General Aviation Division
Rockwell International

SERVICE INFORMATION NO. SI-102

EFFECTIVITY: MODEL 112, SERIAL NO'S 3 THRU 226.

SUBJECT: FAA AIRWORTHINESS DIRECTIVE 74-24-13.

Figure 1.

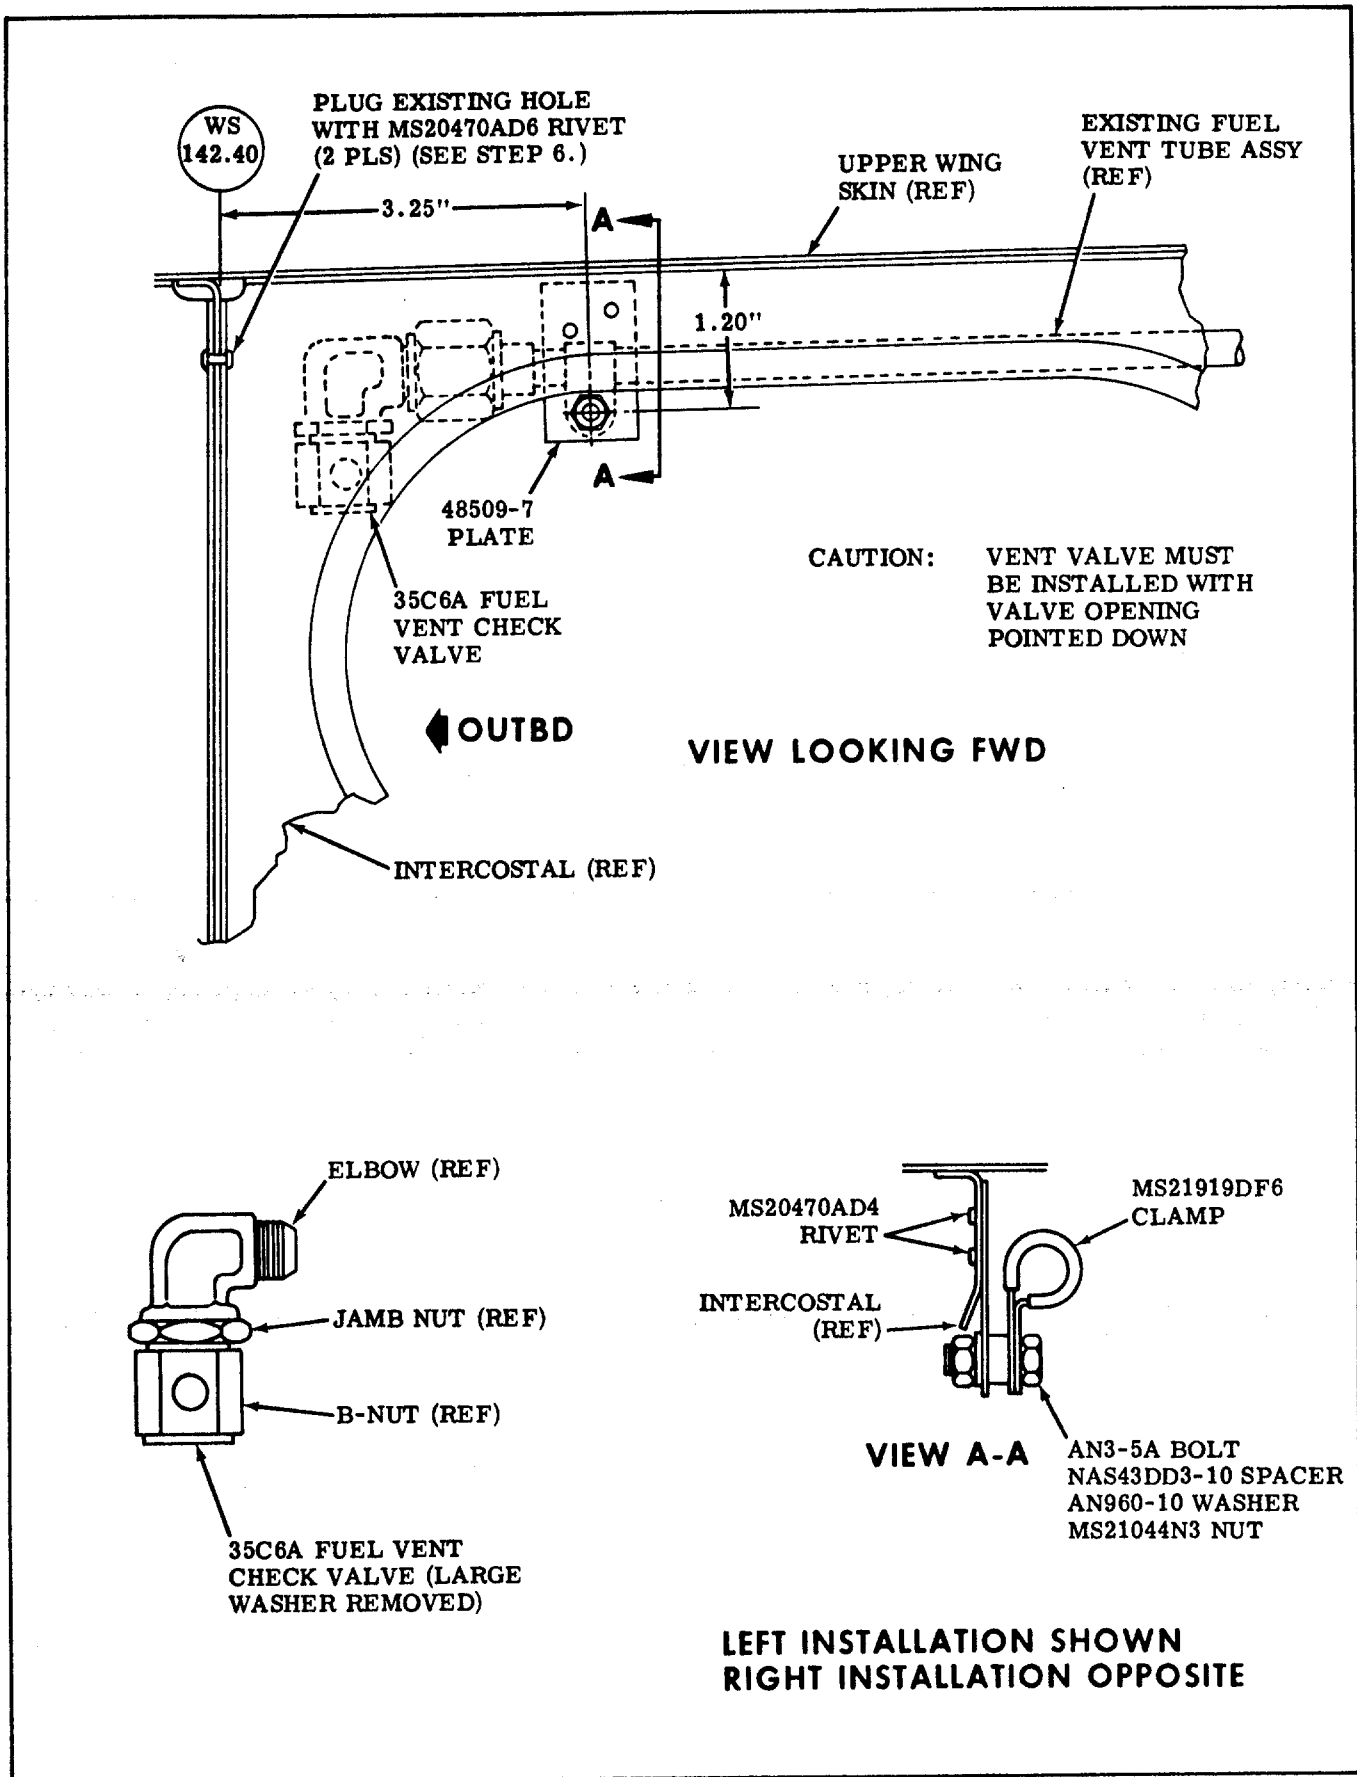
8. Reassemble 35C6A fuel vent check valve as follows (see Figure 1.):
 - a. Install jamb nut on elbow and run nut all the way up on threads.
 - b. Install B-nut on elbow, assuring that the float ball is inside the B-nut, and tighten B-nut on elbow.
 - c. Torque jamb nut against B-nut.
9. Locate, drill and install 48509-7 plate on left and right wing intercostals (see Figure 1.).
10. Install 35C6A fuel vent check valves on left and right fuel vent tube assemblies (see Figure 1.).
11. Install MS21919DF6 clamps (see Figure 1.).
12. Reinstall and reseal lower wing access plates, using PRC-1321, Class B sealant, as outlined in the applicable Airplane Maintenance Manual, Section V.
13. Inspect and pressure check the tanks after sealing compound has cured (approximately 8 to 10 hours) and check for possible leaks.

Figure 1.

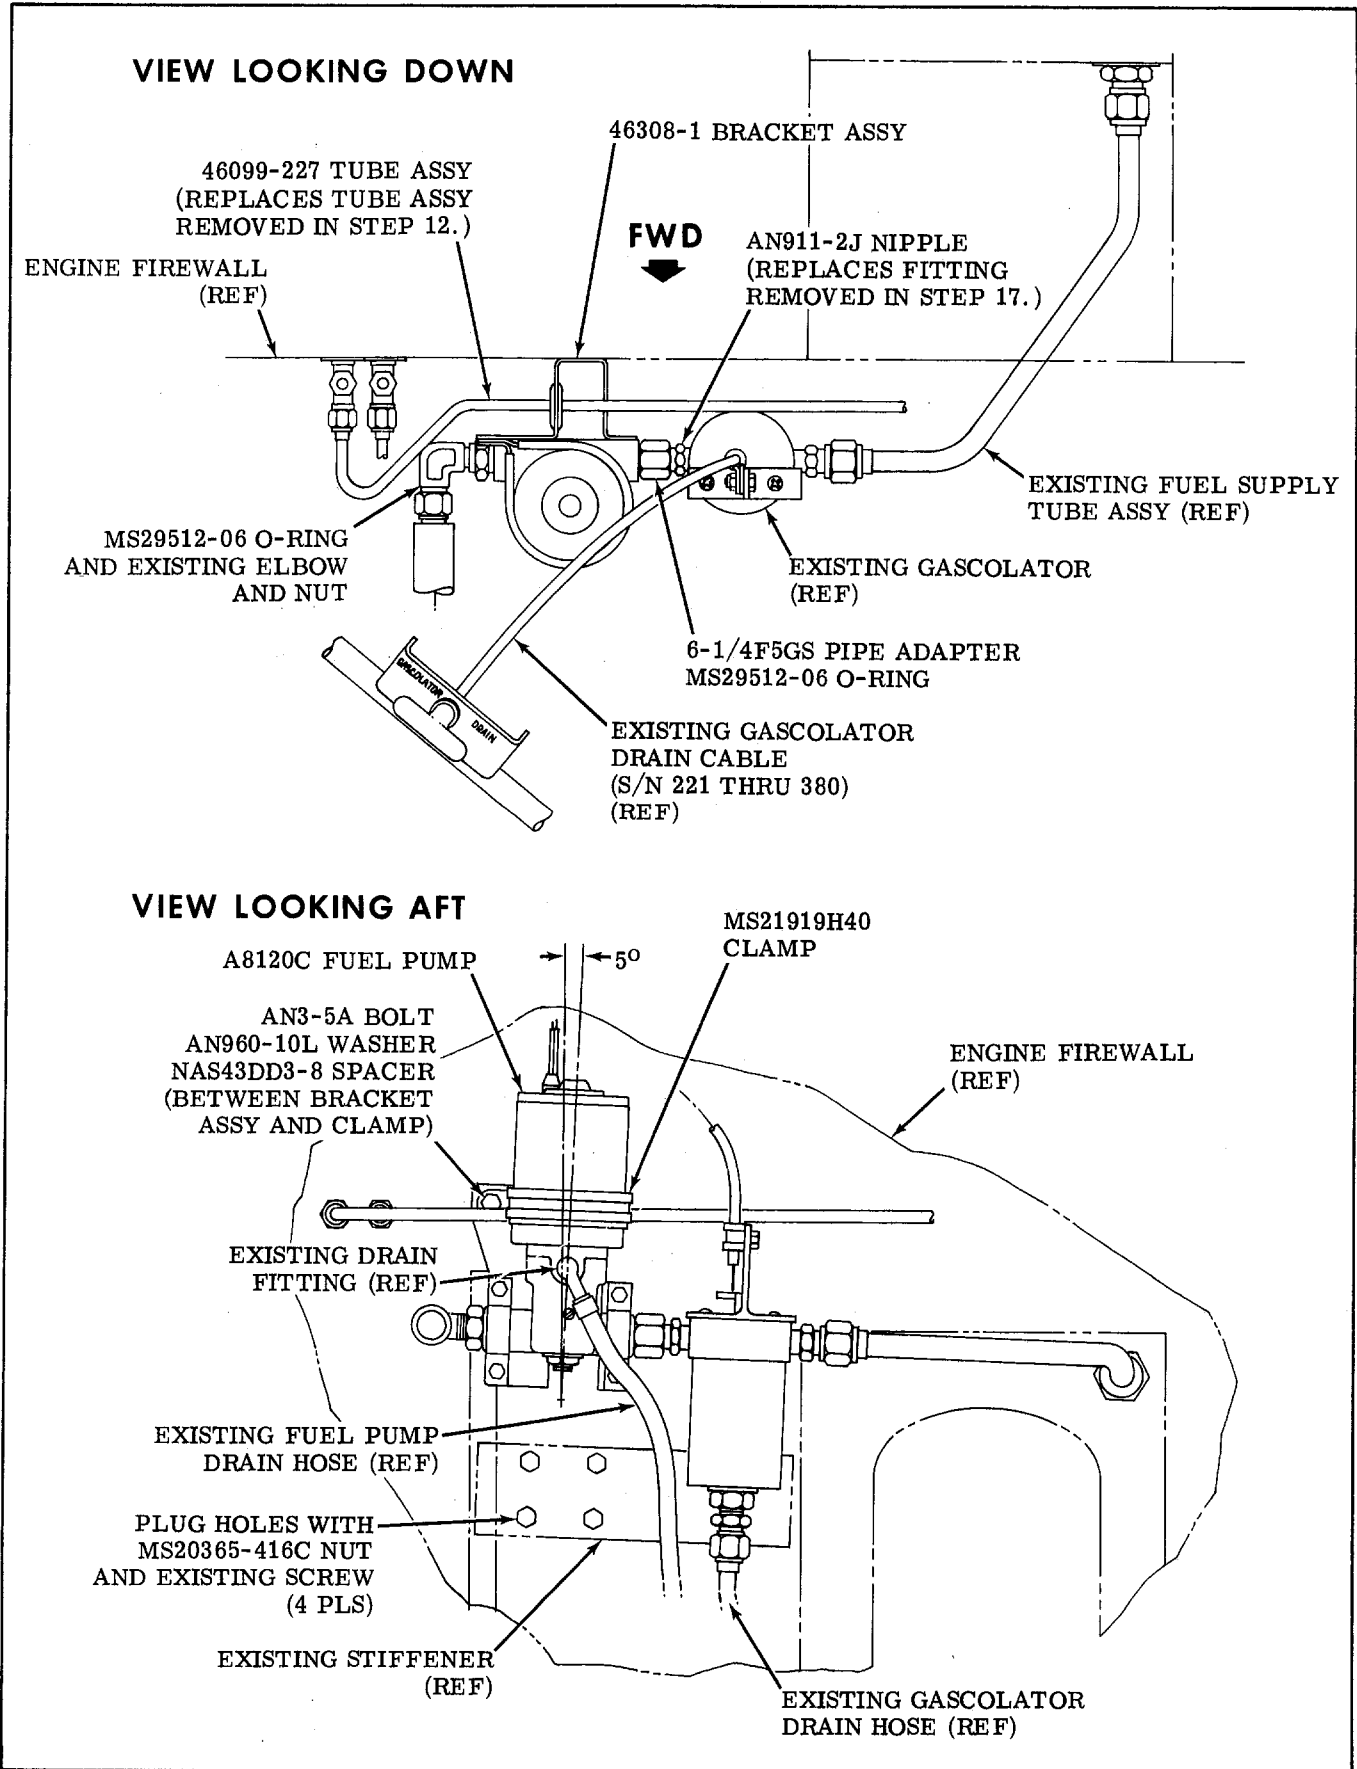
20. Install existing drain fitting on fuel pump (see Figure 1.).
21. Install AN911-2J nipple on existing gascolator (see Figure 1.).
22. Install gascolator on A8120C fuel pump (see Figure 1.).
23. Temporarily install 46308-1 bracket assembly and MS21919H40 clamp on A8120C fuel pump (see Figure 1.).
24. Position A8120C fuel pump and existing gascolator against engine firewall and connect existing tube assemblies and hoses to fuel pump and gascolator (see Figure 1.).
25. Temporarily install 46099-227 tube assembly (see Figure 1.).
26. Mark position of 46308-1 bracket assembly on engine firewall and mark bracket assembly upper attaching hole on engine firewall (see Figure 1.).

31. Install 46099-227 tube assembly on engine firewall fittings (see Figure 1.).
32. Install A8120C fuel pump and existing gascolator and connect tube assemblies and hoses to fuel pump and gascolator (see Figure 1.).

Figure 2.

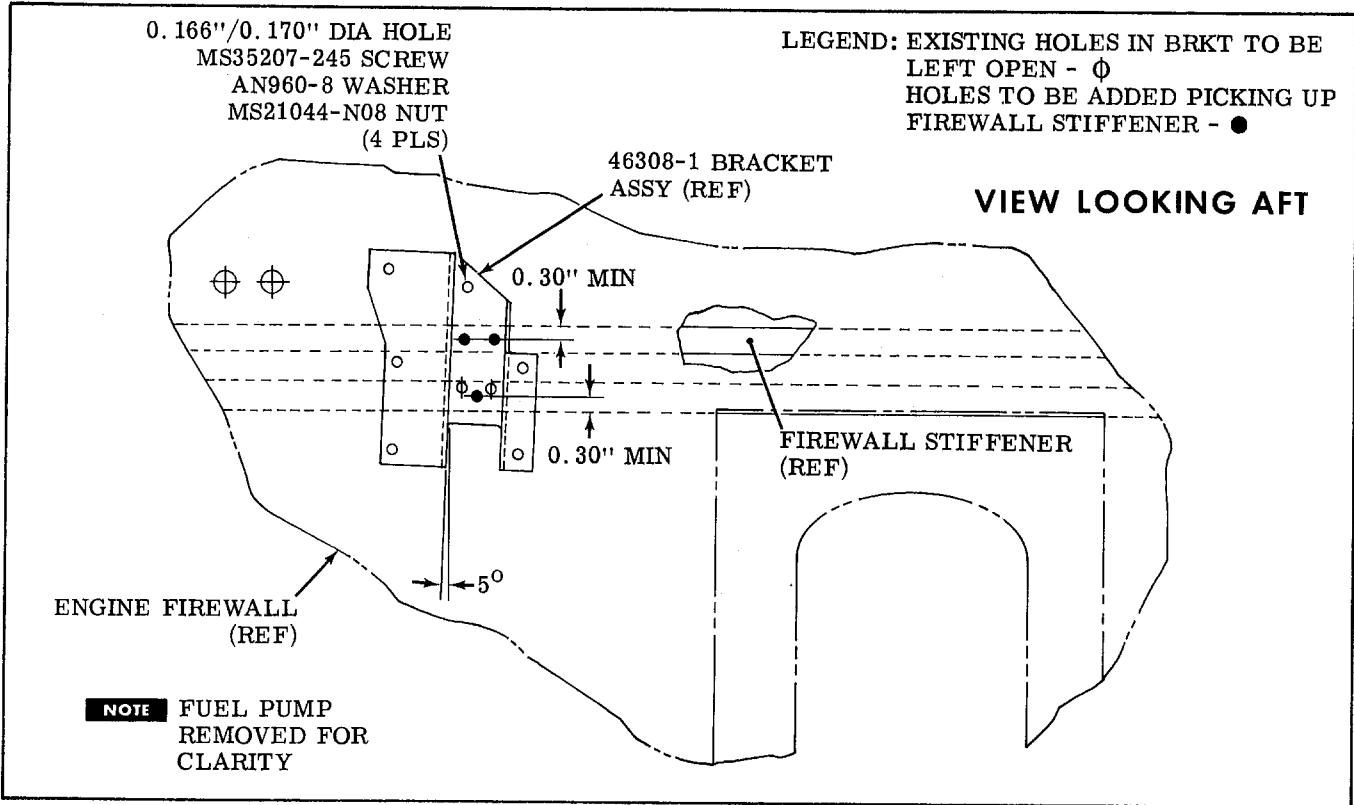
Assure that 46099-227 tube assembly does not rub against bracket assembly grommet and that 46308-1 bracket assembly is oriented with 5 degree tilt as shown in Figure 2.

27. Remove 46099-227 tube assembly from airplane.
28. Disconnect tube assemblies and hoses from fuel pump and gascolator and remove fuel pump and gascolator from airplane.
29. Remove 46308-1 bracket assembly and clamp from fuel pump.
30. Drill and install 46308-1 bracket assembly on engine firewall. Observe 0.30-inch minimum edge distance on stiffener and 5 degree tilt down to gascolator (see Figure 2.).

Figure 3.

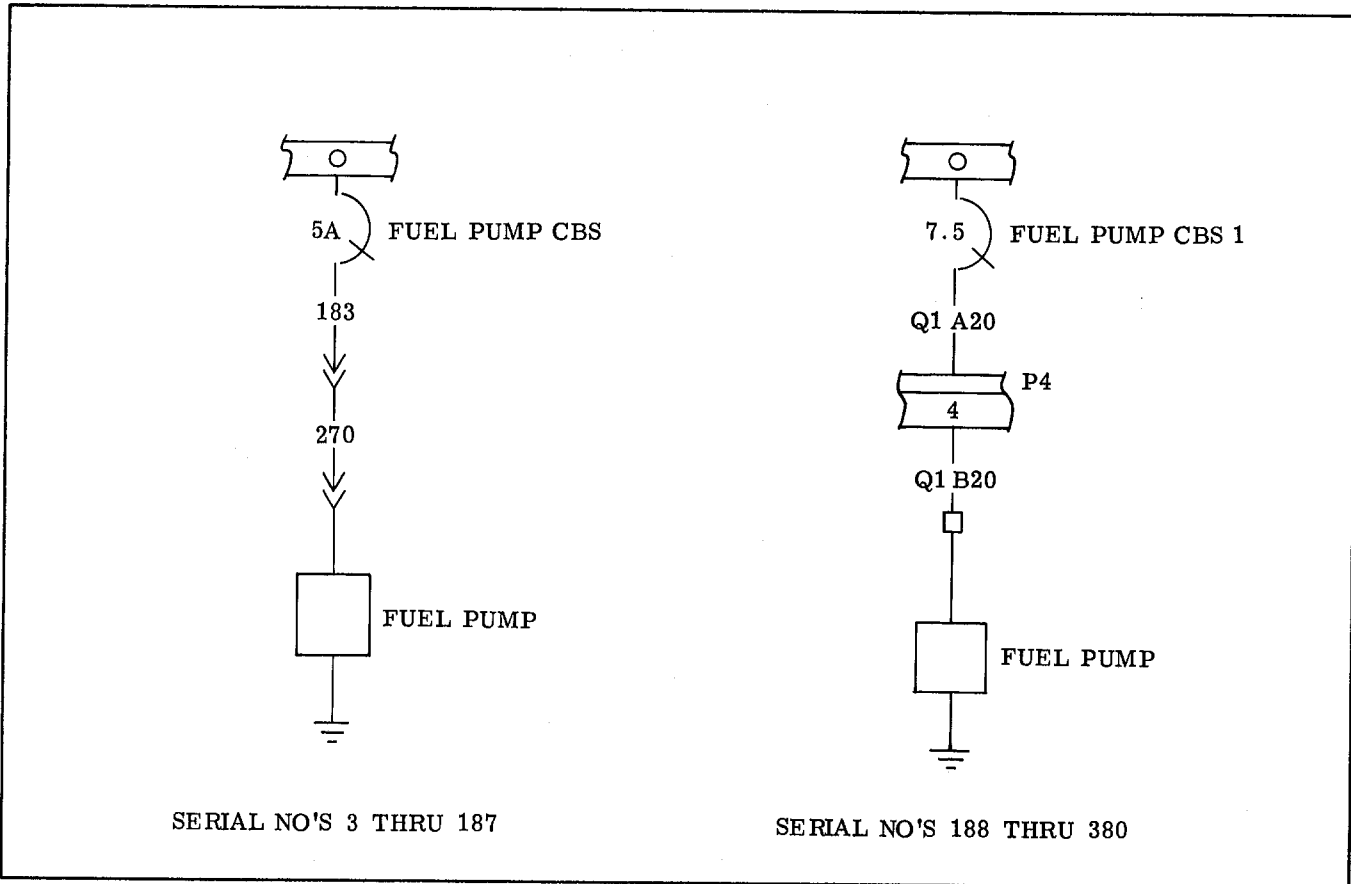
33. On Serial Numbers 221 thru 380, reconnect gascolator drain cable to top of gascolator (see Figure 1.).
34. Connect fuel pump to airplane electrical system (see Figure 3.).
35. Assure that all fuel lines are tightened and no fuel leaks are evident.
36. Reconnect battery cables to battery and install cover on battery.
37. Reinstall baggage compartment liner.
38. Bleed brakes as outlined in the Airplane Maintenance Manual, Section VI.
39. Reinstall upper and lower cowling on engine as outlined in the Airplane Maintenance Manual, Section IV.

Figure 1.

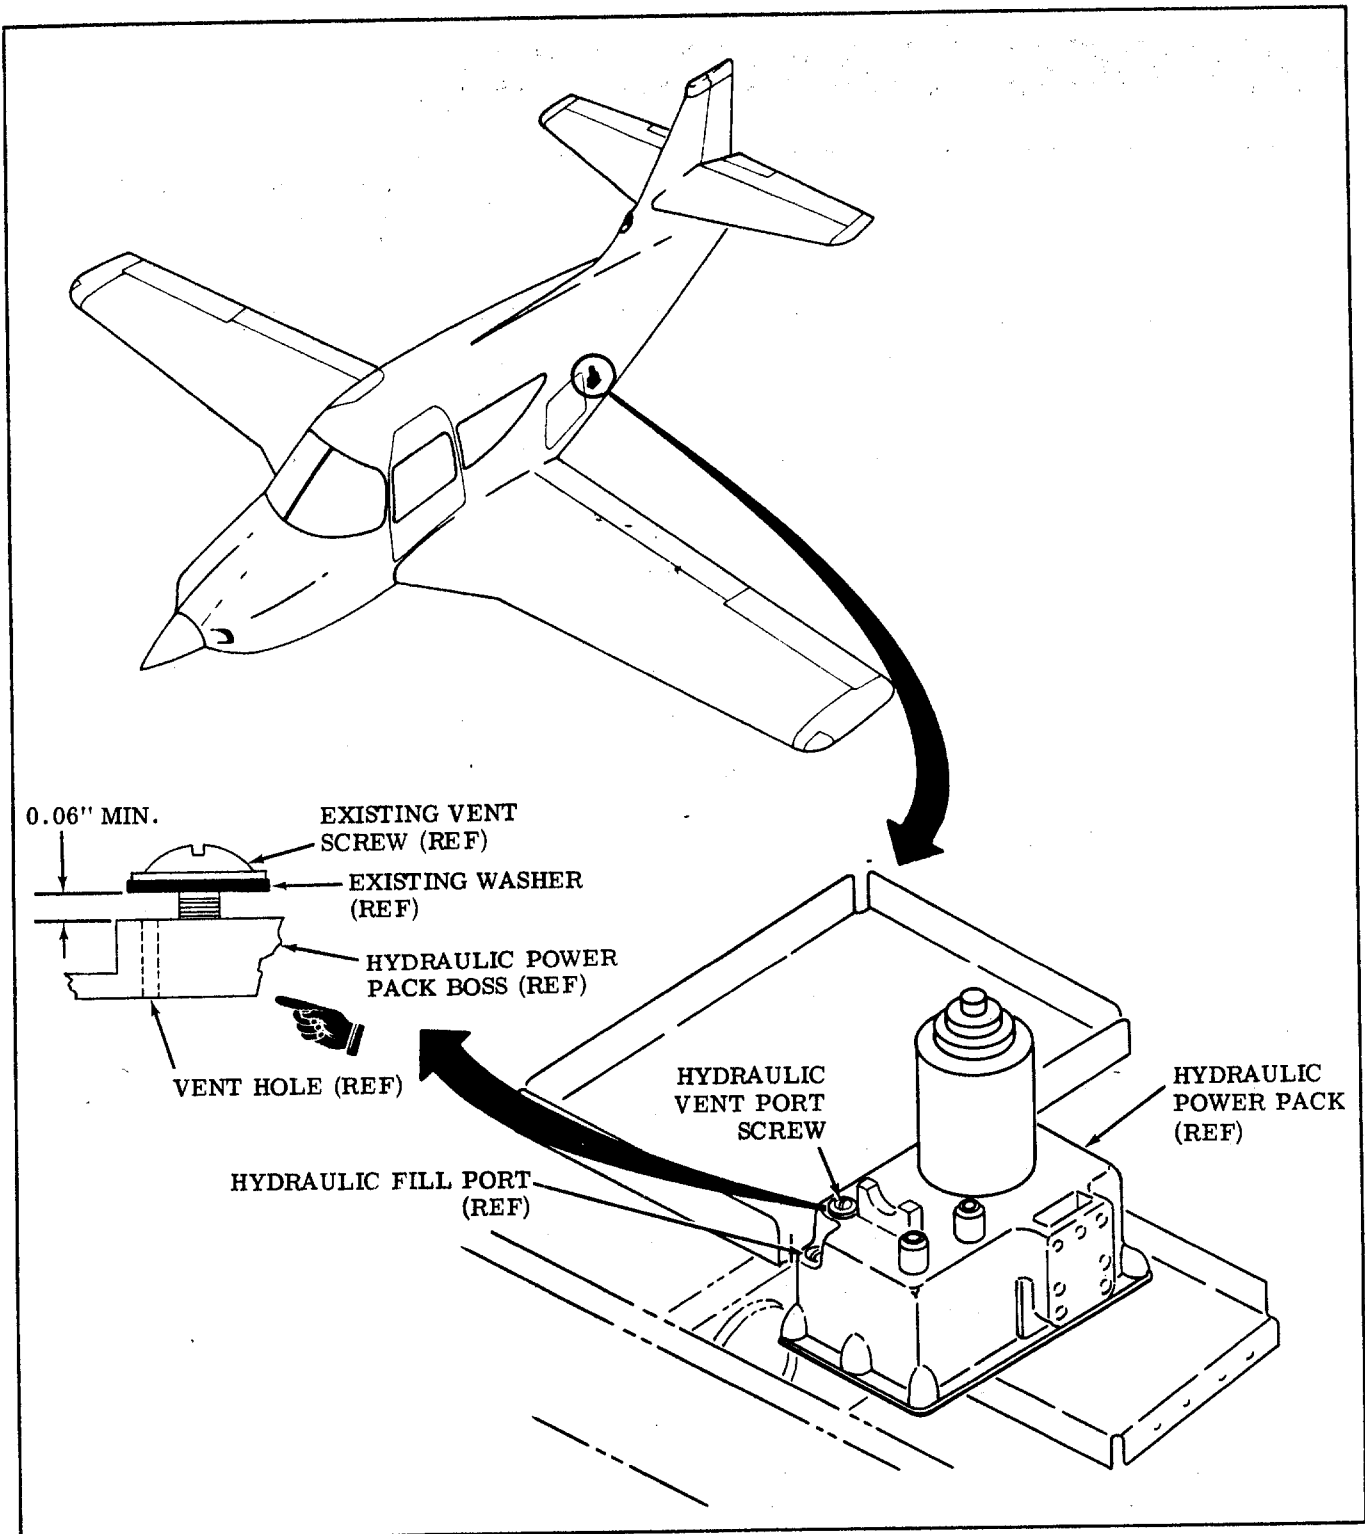
1. Gain access to the hydraulic power pack, located on the left side of the aft fuselage, through the baggage compartment door.
2. Remove the left side baggage compartment access panel to expose the hydraulic power pack.
3. Check hydraulic power pack vent port to assure that clearance between vent port washer and hydraulic power pack boss is a minimum of 0.06 inch (see Figure 1.).

4. If clearance between hydraulic power pack vent port washer and hydraulic power pack boss is a minimum of 0.06 inch, proceed to step 6.
5. If clearance between hydraulic power pack vent port washer and hydraulic power pack boss is less than 0.06 inch, adjust vent screw to obtain proper clearance of 0.06 inch minimum (see Figure 1.).
6. Reinstall the left side baggage compartment access panel.
